Authorized Field Change

AFC G-01914

Subject: Insufficient Torque on the Engine Oil Pick Up Tube Support Mounting Bolt and Nut on International DT 466 and 530 Engines Used in 2654, 4300, 4400, and 7400 Models Built Between October 12, 2001 and December 5, 2001

Figure 2 Applying RTV To Crankcase Rails

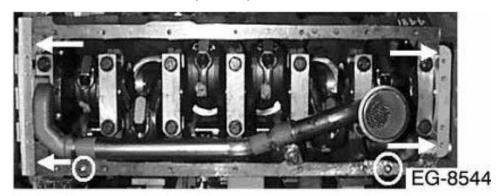
- 6. Using a 10-mm wrench on the pick up tube support bolt head and a 13-mm socket on the nut, tighten the nut to 17 Lbf-Ft (23 Nm).
- 7. Apply a 6 mm (1/4 in.) bead of RTV to the locations shown in Figures 1 and 2:
 - a. Where the crankcase and rear half of the front cover and the crankcase and rear oil seal carrier contact each other.
 - b. Also apply a circle of RTV around the cupped plug crankcase orientation holes located on the oil pan rails of the crankcase.
